**Barrie House, 29 St
Edmund's Terrace, London**
*Comparative Review of CGL BIA
Revision 2 and Revision 4*

Barrie House, 29 St Edmund's Terrace, London – Comparative Review of CGL BIA Revision 2 and BIA Revision 4

Plate 2. Proposed basement beneath extension in Revision 4.

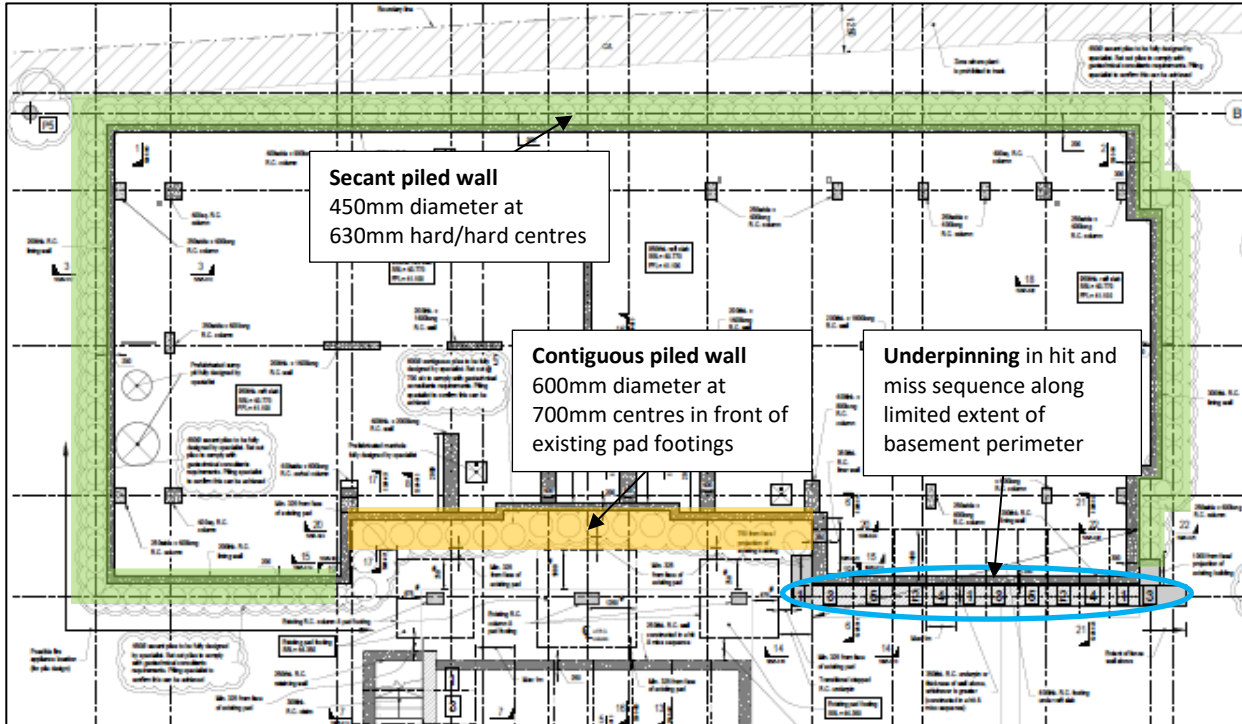
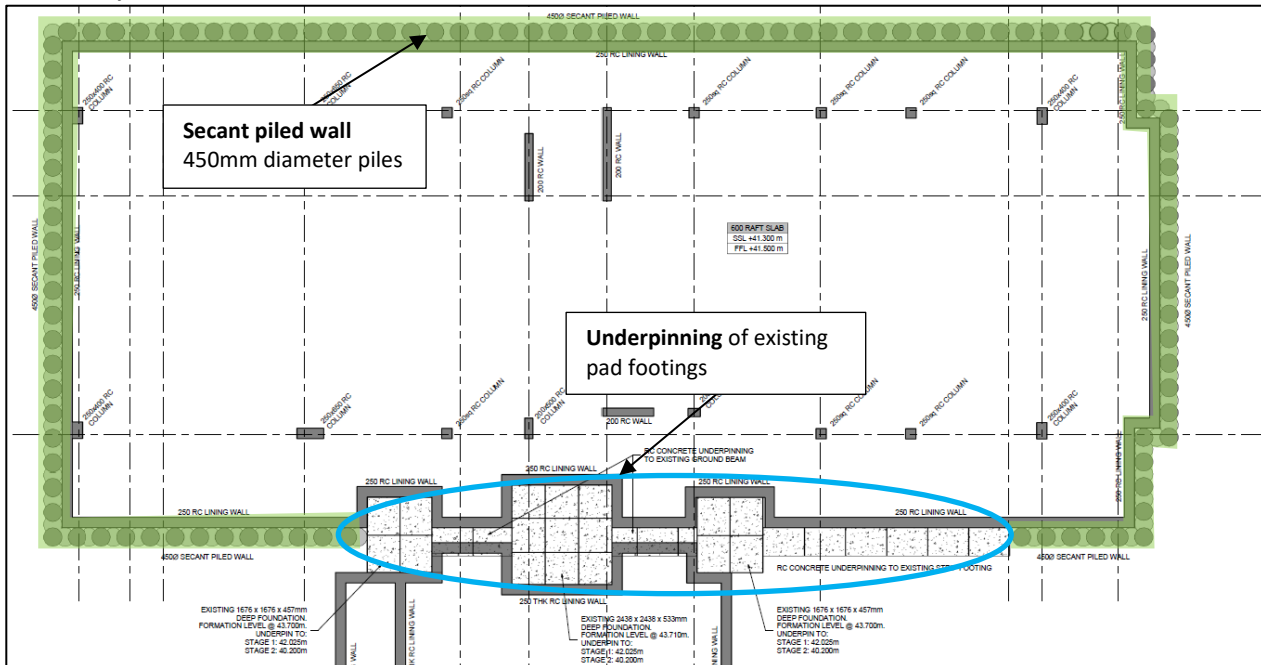
CGL BIA Revision 2	CGL BIA Revision 4	CGL comment
2.3 Proposed Development	2.3 Proposed Development	
<p>Proposed basement beneath Barrie House:</p> <ul style="list-style-type: none"> • SSL = +42.8mOD FL = +42.5mOD • Founded on 300mm thick basement slab <p>Proposed basement beneath extension:</p> <ul style="list-style-type: none"> • SSL = +40.70mOD • FL = +40.20mOD • Founded on 500mm thick pad foundations • Constructed within a 450mm diameter secant piled wall • In front of the existing Barrie House pads, it is constructed by underpinning the existing pad foundations 	<p>Proposed basement beneath Barrie House:</p> <ul style="list-style-type: none"> • SSL = +42.475mOD to +42.875mOD • FL = +42.175mOD to +42.575mOD • Founded on 300mm thick basement slab <p>Proposed basement beneath extension:</p> <ul style="list-style-type: none"> • SSL = +40.770mOD • FL = +39.770mOD • Founded on a 950mm thick raft foundation • Constructed within a 450mm diameter secant piled wall • In front of the existing Barrie House pads, it is constructed within a 600mm diameter contiguous piled wall • Underpinning is proposed along a limited extent of the south-east perimeter • High and low level props utilised during excavation to minimise deflection 	<p>Underpinning of the existing pad foundations is no longer proposed. In front of the pads, the basement will now be excavated in front of a contiguous piled wall. Local underpinning of the one storey structure is proposed. CGL has previously provided a letter report⁴ in September 2022 concluding that the existing pad foundations are highly stressed and strongly recommended against underpinning the existing pad foundations. Therefore, the approach in Revision 4 preferred.</p> <p>The formation level of the basements are marginally deeper in Revision 4. The ground movement assessment has been updated accordingly and the resulting damage categories are discussed at the end of this table.</p>
